**May 13, 2008**

**SUBJECT:**           **2007-0065** – Applicant appeal of a decision of the Planning Commission to deny an application for **688 Conway Road** (near Hollenbeck Ave) in an R-2 (Low-Medium Density Residential) Zoning District.

Motion               Design Review to allow a new two-story single family residence for a total of 3,448 square feet and 62.9% FAR (Floor Area Ratio) where 45% FAR may be allowed without Planning Commission review.

FRONT ELEVATION  
SCALE: 1/4" = 1'-0"

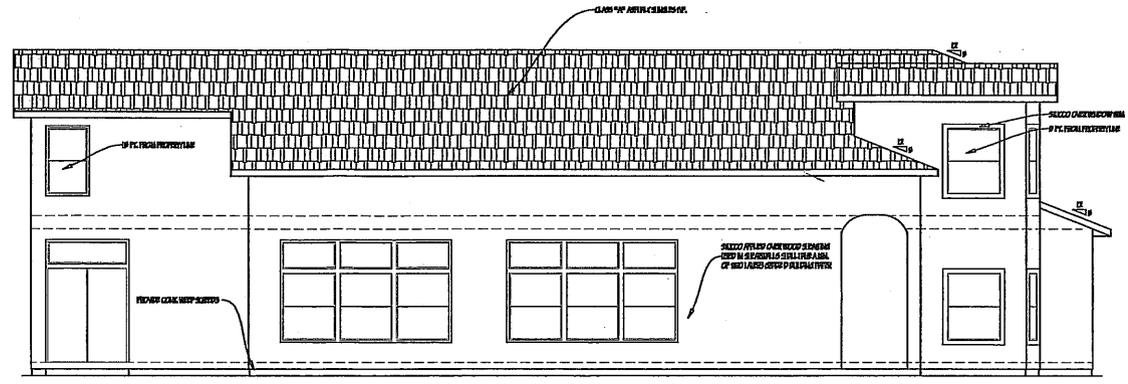
**Architecture:** The proposed architecture is contemporary, with stucco siding and composition shingle roof material. The front façade of the home is dominated by the proposed garage door and a two-story bay window feature. The front entry is approximately 18 feet in height, and is recessed approximately 10 feet from the bay window feature and 14 feet from the face of the garage. The windows are a mix of double-hung and fixed windows, with window trim. Additional ornamentation includes a pair of arched windows on the front elevation of the second floor, with trellis features below.

*Massing and Bulk:* There are design elements that contribute to the massing and bulk of the home. These elements include the two-story bay window feature, front entry, vaulted ceiling along the left side of the home, and the flat walls. Staff believes that there are options available for the applicant to modify these features, that could reduce mass and bulk, but these would require significant changes to the home:

- The entry feature shall not exceed a total height of 14 feet. This reduced height would allow for compatibility with the modest entries also found in the neighborhood.
- Additional design features shall be added along the front, side and rear elevations, such as wall trim, window trim or wainscoting along the base of the building. This would provide better articulation and visual interest to the flat elevations.
- The two-story bay window feature shall be removed/relocated and the home should be redesigned to become the front entry to the home. Relocating the front entry would allow the entry to be more visible from the street front.

- Relocate the front elevation of the garage farther back/south on the lot, or at a minimum, a trellis should be added along the top of the garage door. The current elevation is dominated by the garage doors. Although the narrow lot width may limit the design options for the garage doors, there is adequate opportunity to move the garage back. At a minimum, added detailing on the garage wall would help to break up the massing of the wall.

*Alternative Elevations (Attachment F):* In an attempt to address staff's concerns, the applicant submitted an alternative front elevation drawing contained in Attachment F. This alternative elevation includes a modified two-story bay window, reduced front entry height, and additional wood trim. The bay window feature would be modified into a two-story flat wall with standard windows, wood trim and a front gable. In addition, the entry would be reduced to a height of 14 feet. Wood trim would also be added to the base of the first floor and wrap around the entire home.

This alternative elevation design incorporates some of staff's concerns, the applicant submitted an alternative front elevation drawing contained in Attachment F. This alternative elevation includes a modified two-story front window, reduced front entry height, and additional wood trim. The front window feature would be modified into a two-story flat wall with standard windows, wood trim and a front gable. In addition, the entry would be reduced to a height of 14 feet. Wainscoting would also be added to the base of the first floor and wrap around the entire home. The wainscoting is proposed to be wood trim, but could be stone or masonry.

This alternative elevation design incorporates some of staff's recommended conditions, such as providing additional architectural wall detailing, and reducing the height of the front entry. Although this alternative helps address some of the design issues, the proposed home is still massive and more effective solutions are needed to reduce the square footage (most likely on the second floor), reduce the vaulted ceilings and to also push the garage back (Attachment B, Recommended Conditions of Approval).

It should be noted that the garage dominates the façade of the building due to the narrow lot. Some would consider this design to be a “snout house” which is a term used for front forward garage designs and is discouraged in the

Sunnyvale Single Family Design Techniques. Staff recommends that the garage be pushed back/south to reduce its visual impact. Alternatively, at a minimum, a trellis feature could be added along the top of the garage doors to provide some relief from the garage elevation (Attachment B, Recommended Conditions of Approval).

- The entry feature shall not exceed a total height of 14 feet, comparable to the garage.
  - Additional design features shall be added along the elevations, such as wall trims, windows trims or wainscoting along the base of the building.

- The two-story front window shall be removed and redesigned to become the front entry to the home.
  - The front elevation of the garage should be pushed further back/south. Alternatively, at a minimum, a trellis feature shall be added along the top of the garage door.

- The garage shall be set back further and the front door shall be moved forward to make the entry the primary visual features of the home. Associated modifications to the floor plan and elevations shall be incorporated into the project design.

**SOLAR ANALYSIS**

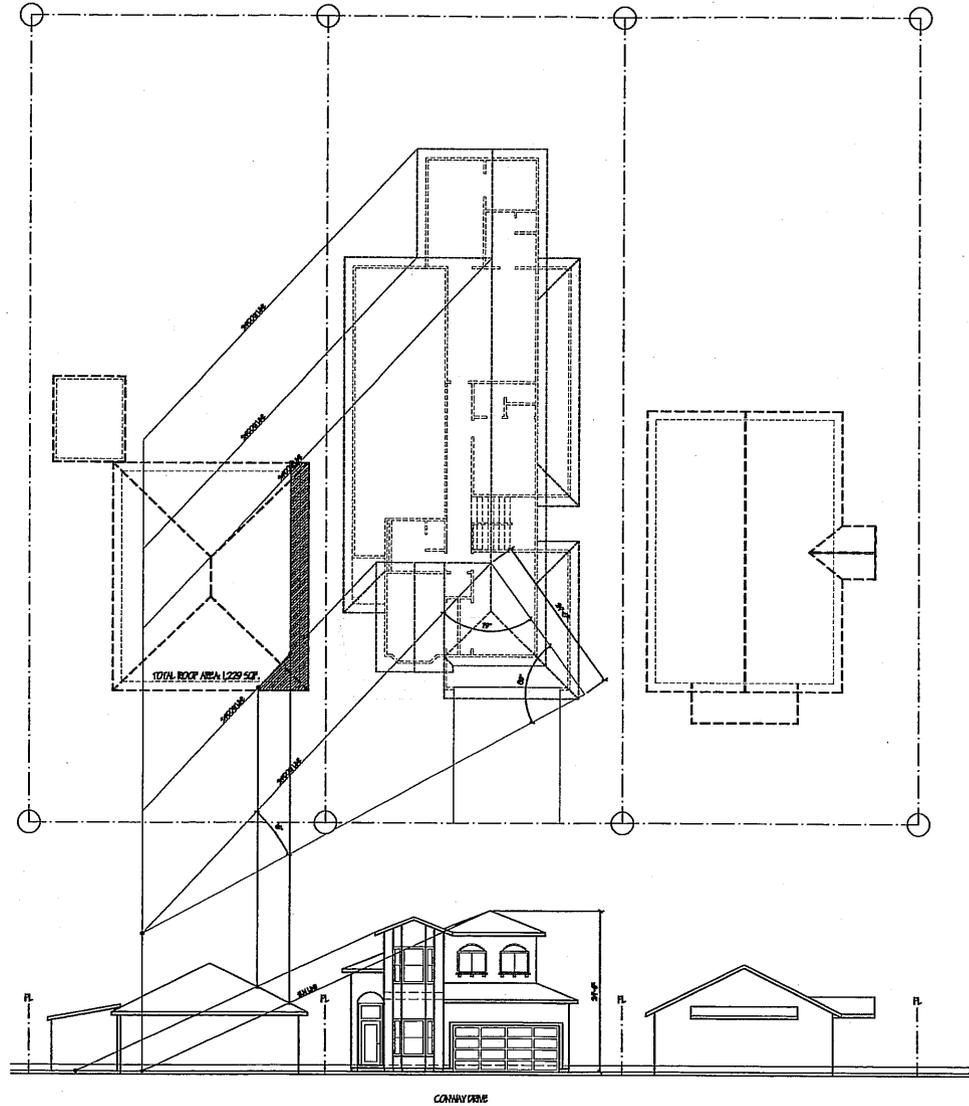
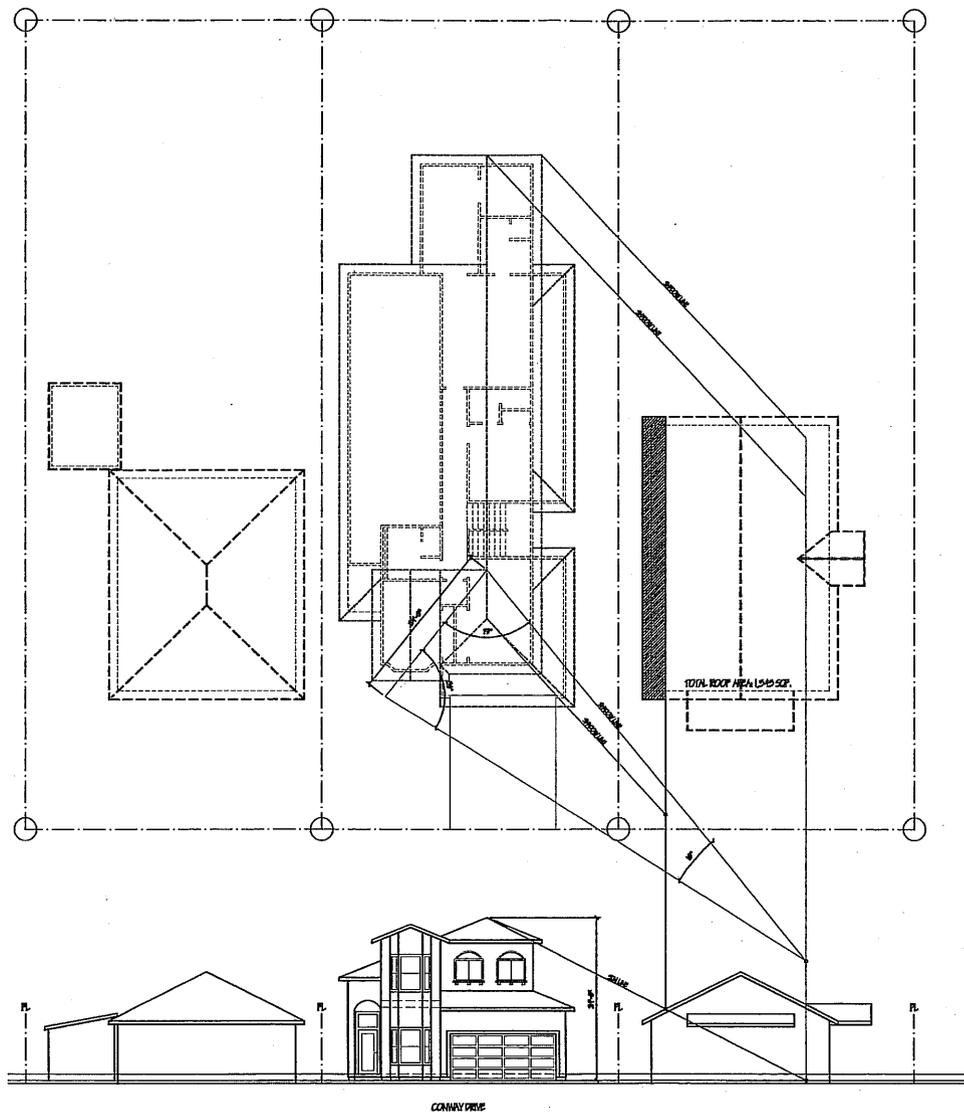
In addition, the applicant has submitted a solar access and shadow analysis which demonstrates that the proposed two-story home will shade no more than

8.95% of the existing one-story home on the left side of the property, where 10% is the maximum allowed.
